RAPID NEWS

N°: RN/Technical info/11-23

SUBJECT: Wiring for the option PCB EKR1C11 in combination with the valve kit EKMV2/3 on the four pipes FWF & FWC-B units.

Figure a

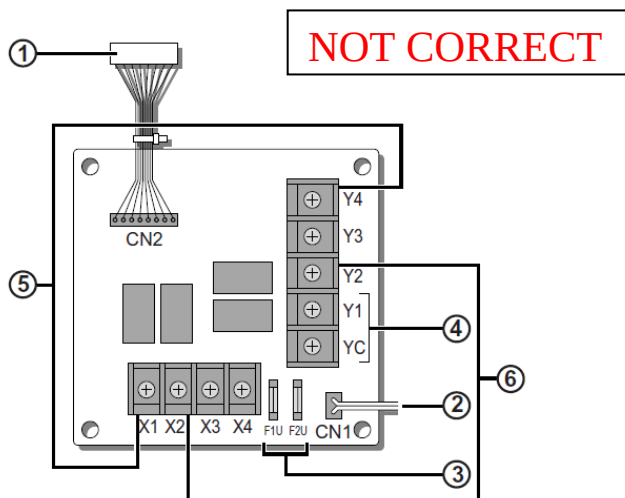
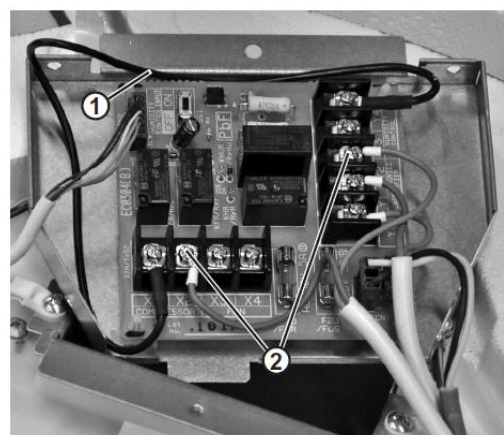
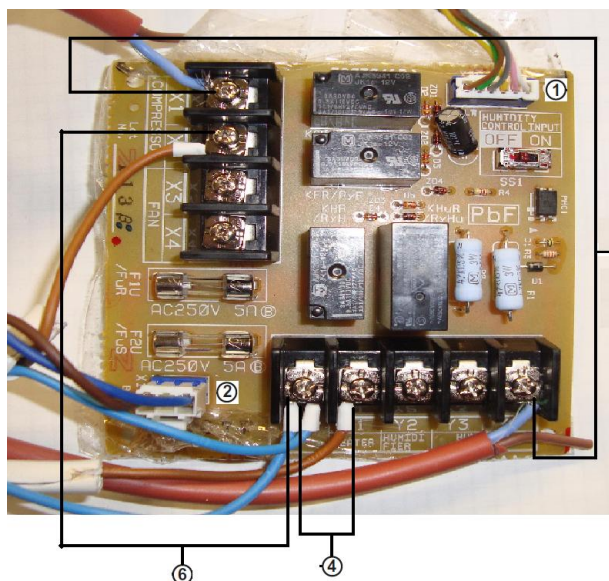
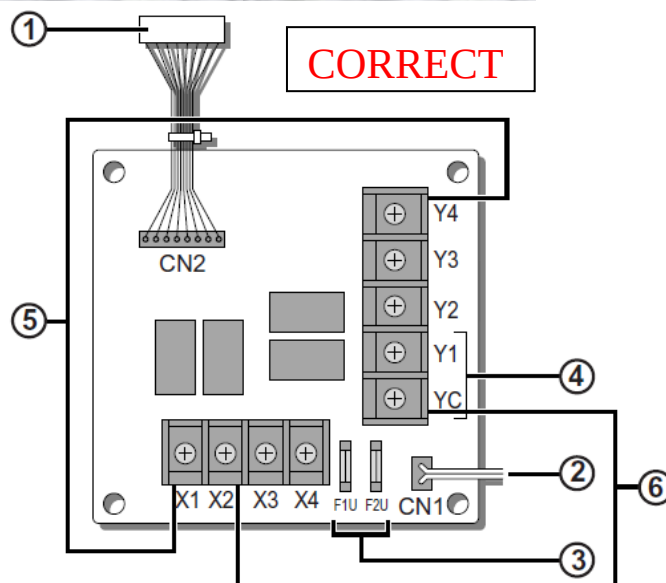
Through this communication we want to inform you of a wrong indication in the wiring diagram included with the EKMV2/3 option.

When wired as explained in the installation manual for the EKMV2/3 (see below figure a) the heating valve doesn't activated. Therefore the wiring has to be changed by the new wiring diagram (figure b)

- 1 X1-Y4 wire
- 2 X2-Y2: connection of the second valve

Figure b

- 1 communication to fancoil PCB
- 2 Power supply wire (to fan coil unit)
- 3 Fuses 5 A – 250V
- 4 YC-Y1: connection of first valve
- 5 X1-Y4: wire to enable the use of the second valve
- 6 X2-YC: connection of second valve

The wiring diagram will be changed inside the option kit, so that further miss wiring will be prevented.
